Subject: Braidwood Generating Station Units 1 and 2  
 Masonry Walls  
NRC Docket Nos. 50-456 and 50-457

Response to NRC Request for Additional Information  
on Masonry Wall Design Based on Telephone  
Conversation Request From NRC of July 1, 1983  
Response to Braidwood FSAR Question 130.60

Braidwood Masonry Wall Crack Survey

WALL ELEVATION  
 PARTITION WALL 3A-34  
 BRAIDWOOD STA. UNIT 1&2  
 COMMONWEALTH EDISON CO.  
 CHICAGO, ILLINOIS

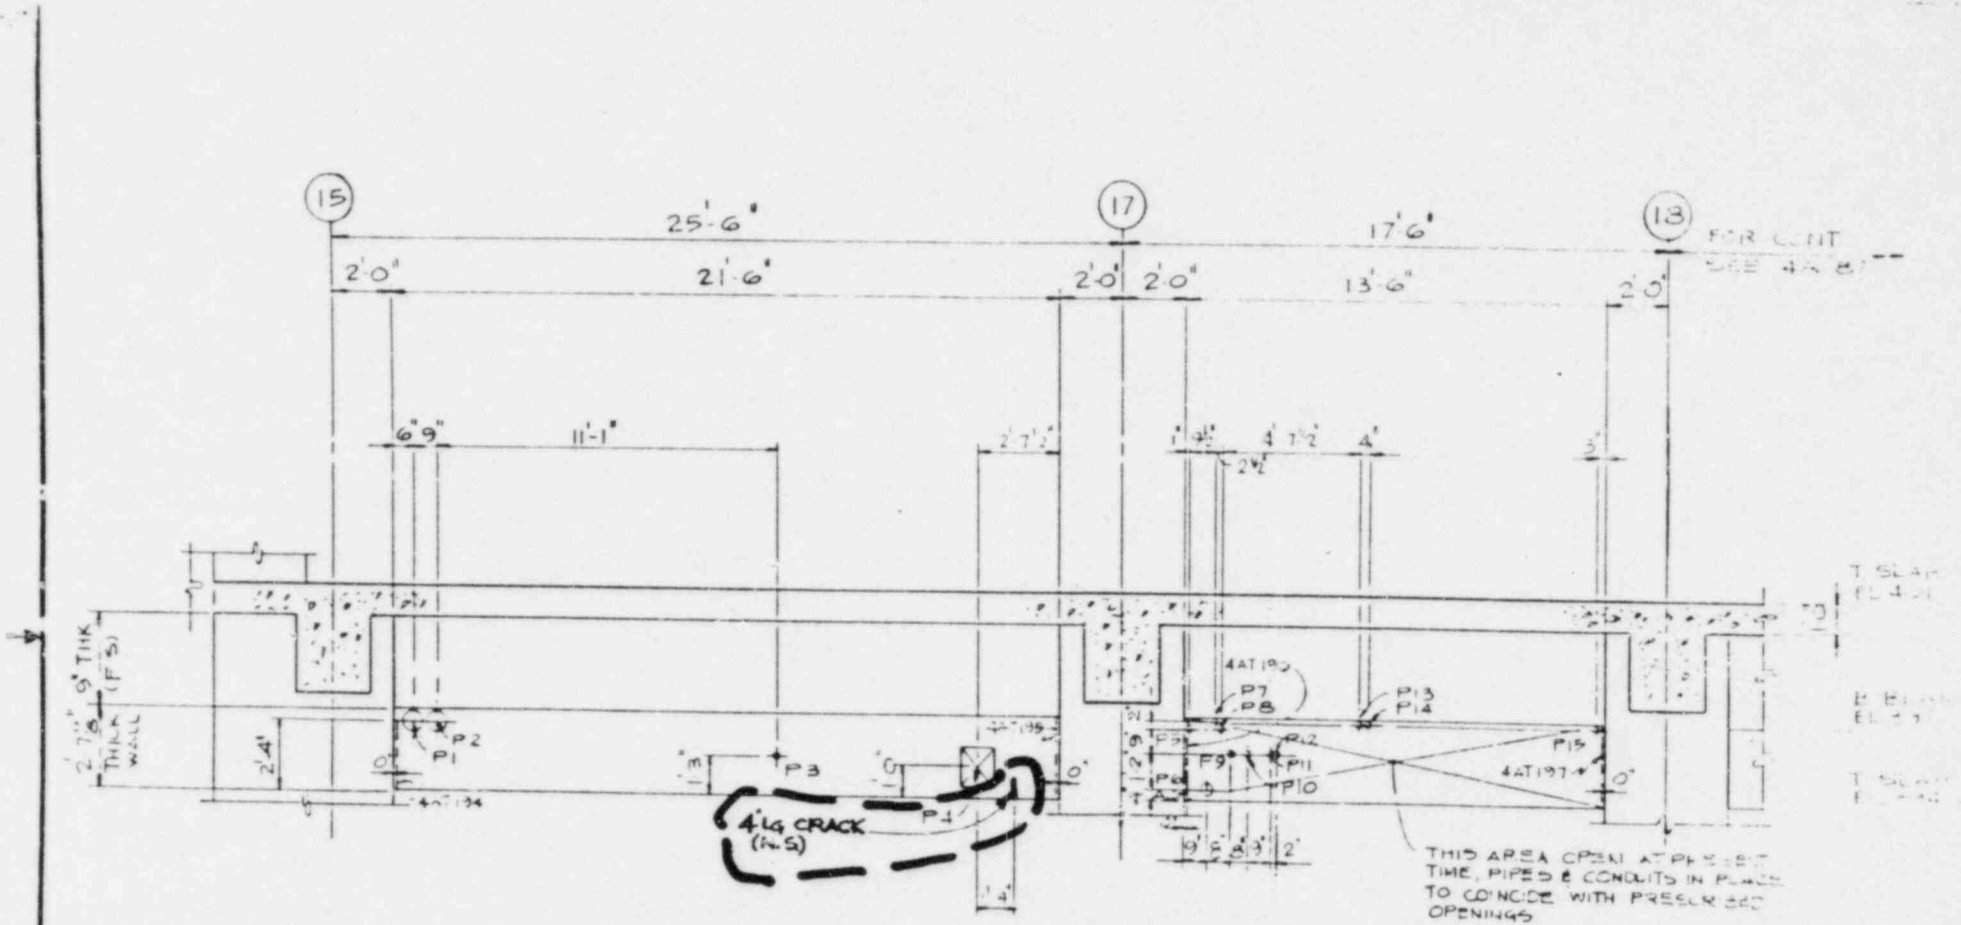
2. Vertical Non-Thru Cracks at the Top or Bottom of Wall Elements	SK-3A-07 SK-3A-34 (C2) SK-4A-86 SK-6A-68A (C1) SK-7A-03A SK-8A-26 SK-9A-07 SK-9A-18	Local cracks in one or two blocks at the top or bottom of the wall have no affect on its structural integrity.

4. Vertical Cracks at Columns	SK-3A-34 (C1) SK-6A-81 SK-8A-03 SK-8A-30 (Cracks near column line 17 and column line 15) SK-9A-01 (C2, C3)	A modification has been installed at 8A-30's crack (located at 17 line) to ensure structural integrity. Walls 3A-34, 8A-30 (15 line), 6A-81, 8A-03, and 9A-01 (cracks C2 and C3) contain local non-thru vertical cracks at support locations (masonry wall columns or abutting wall). These cracks do not affect the structural integrity of the wall since the wall is assumed to span horizontally and the cracks are located at theoretical hinge points of simply-supported spans.

WALL ELEVATION	
PARTITION WALL 2A-47A	
BRAIDWOOD STATION UNITS 1B2	
COMMONWEALTH EDISON CO	
CHICAGO, ILLINOIS

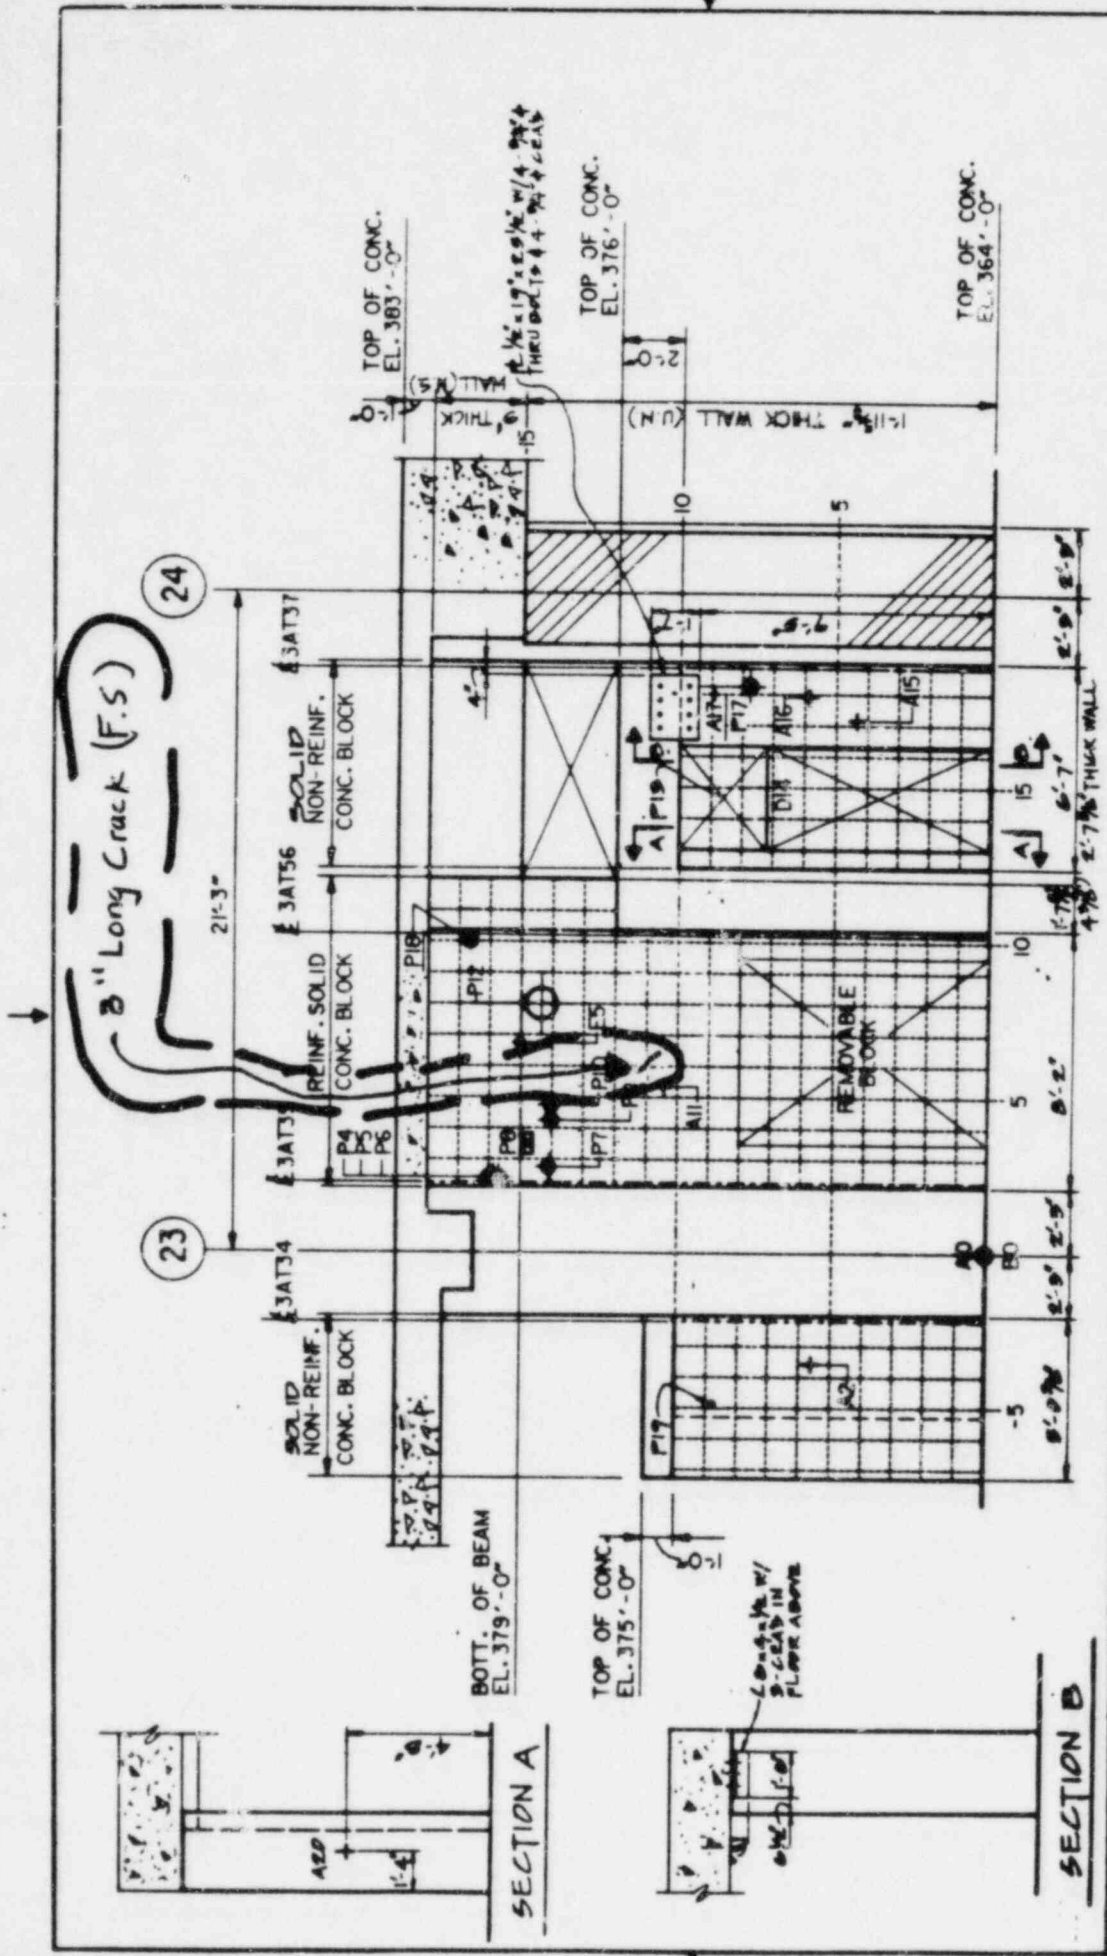
3. Local Non-Thru Cracks in the Interior of the Wall Element	SK-2A-43 SK-2A-47A SK-3A-29 SK-4A-30 SK-4A-84 (C1, C2, C3) SK-4A-85 SK-5A-19A SK-6A-68A (C2) SK-6A-70A (2 cracks) SK-7A-09 SK-9A-11 (C1, C2) SK-9A-26	Local cracks in one or two blocks in the interior of the wall have no affect on its structural integrity.
